62HDX Jockey Wheel Replacement

The Heavy Duty Jockey Wheel for the 62HDX machine (Part number 1210-80) has been shown in some cases to experience fatigue cracking leading to a failure of the shaft during operation. A new design (part number 1210-85) has been proven, eliminating the source of the fatigue cracking and using a larger diameter shaft.

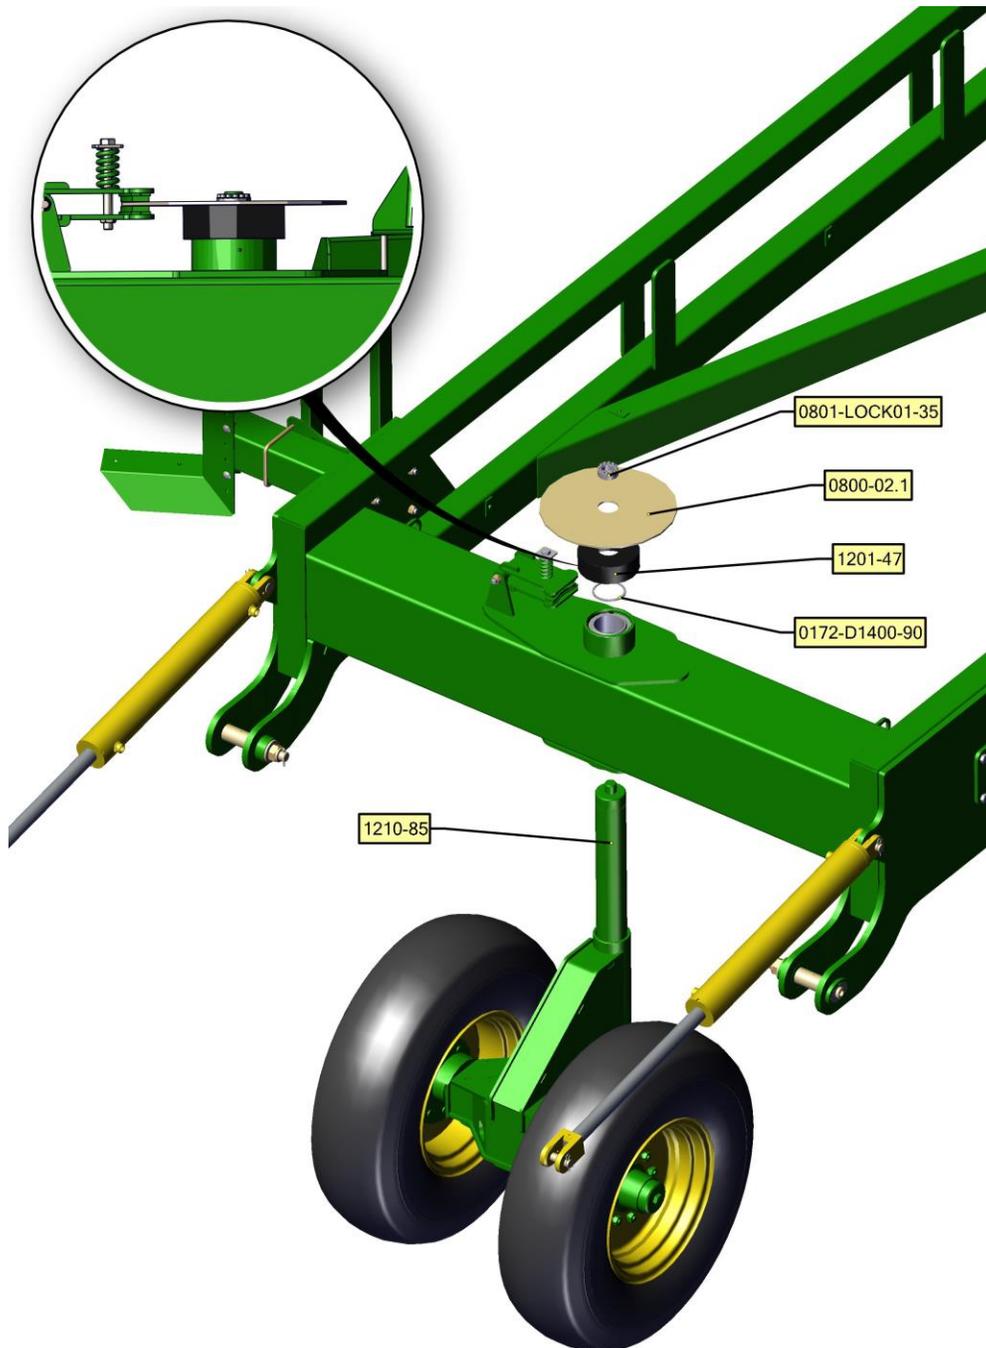
1. Support the Rear A-Frame (1265-03) on trestles to allow disassembly to occur.
2. Remove wheels and stub axles from jockey wheel assembly.
3. Loosen Clamping Element (0801-LOCK01-35) bolts, remove Clamping Element and Brake Caliper Plate (0800-03.1).
4. Remove jockey wheel assembly (1210-80) and replace with 1210-85.
5. Install circlip 0172-D1400-90 in the groove on the shaft above the top bearing.
6. Replace existing dust cover (1201-43) with replacement dust cover (1201-47)

Complete steps 1-3 in reverse to complete the installation process.

NOTE:

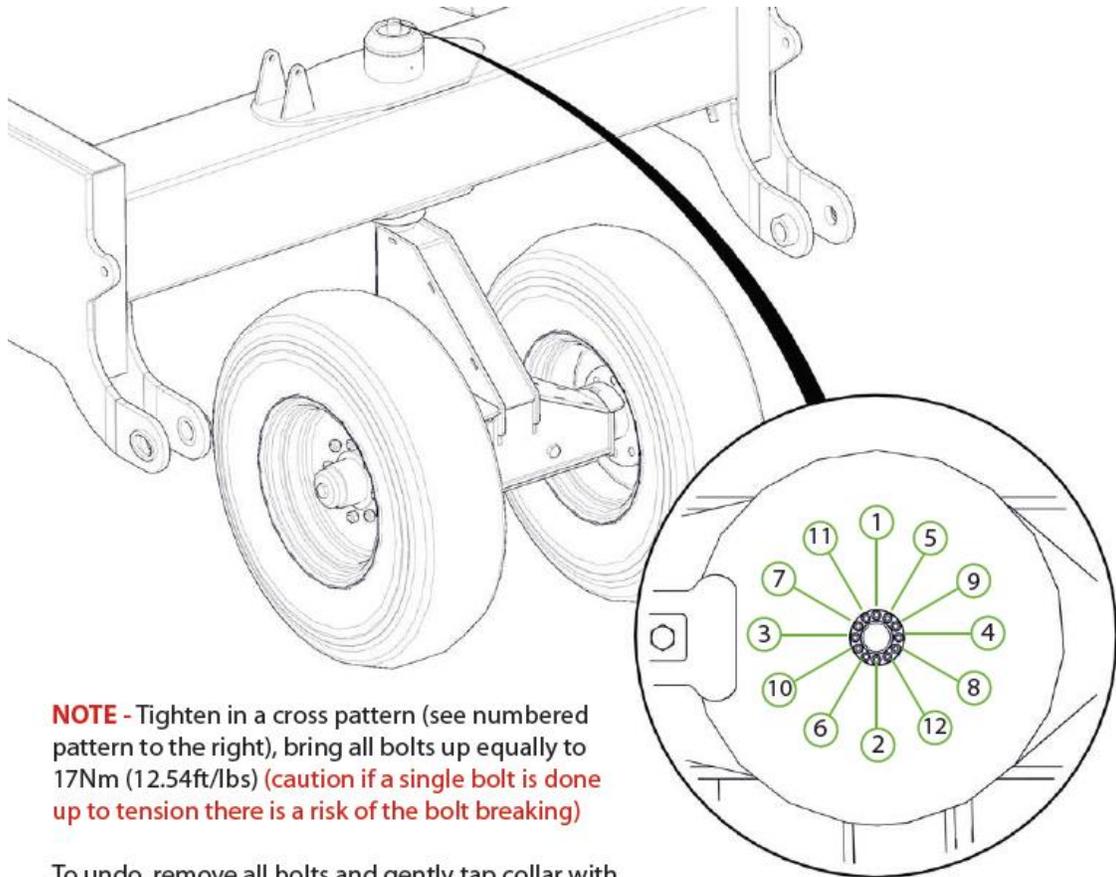
NOTE - Tighten in a cross pattern (see numbered pattern to the right), bring all bolts up equally to 17Nm (12.54ft/lbs) (caution if a single bolt is done up to tension there is a risk of the bolt breaking)

To undo, remove all bolts and gently tap collar with hammer. The collar will become loose.
